95-97 WALTON STREET

APPLICATION FOR PERMIT
DEPARTMENT OF BUILDING INSPECTIONS SERVICES
ELECTRICAL INSTALLATIONS

97 Walton St.--New Garage for Wayne Dixon by Carroll Beck, Builder-----4/25/45

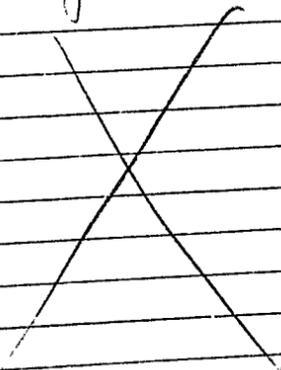
No locations or number of piers proposed for foundations are shown on the application or sketch.

The 4x6 sill ought to be set with the 6-inch dimension upright.

If gable end, pitch roof is proposed, besides the piers at the corners, there ought to be at least two intermediate piers, uniformly spaced, under each side where the eaves occur.
